**APPENDIX L: ANSWERS TO THE OFFICIAL COMMENTS
AND OBSERVATIONS ON THE D.F.R**

March 29, 1985
Office No. DE-199-85

CHAPTER I
GENERAL CONCEPT

5.3.2 Project Operation and Maintenance Organization

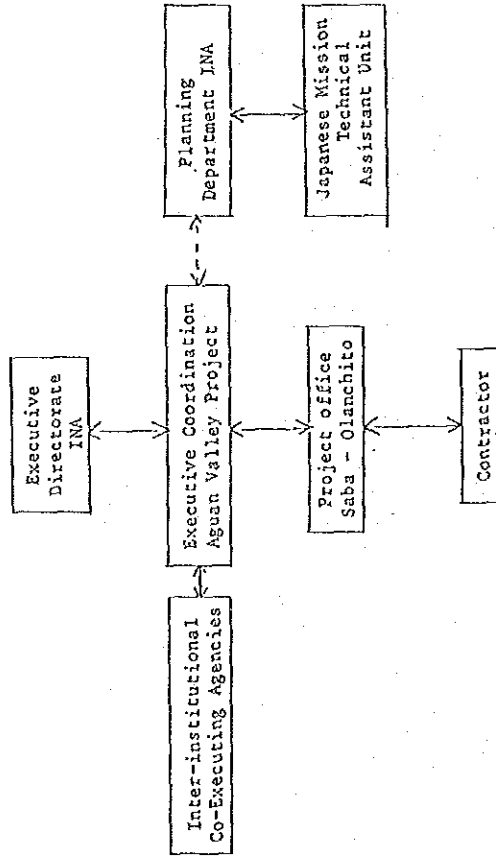
We advise that the proposed chart in page 5-6 would be revised on the inter-institutional scheme of the Government of Honduras and the interior of National Agrarian Institute as illustrated.

The organization charts in pages 5-8 and 5-11 should be also modified based on this proposal.

project implementation, operation and maintenance organization are revised a shown in the Main Report.
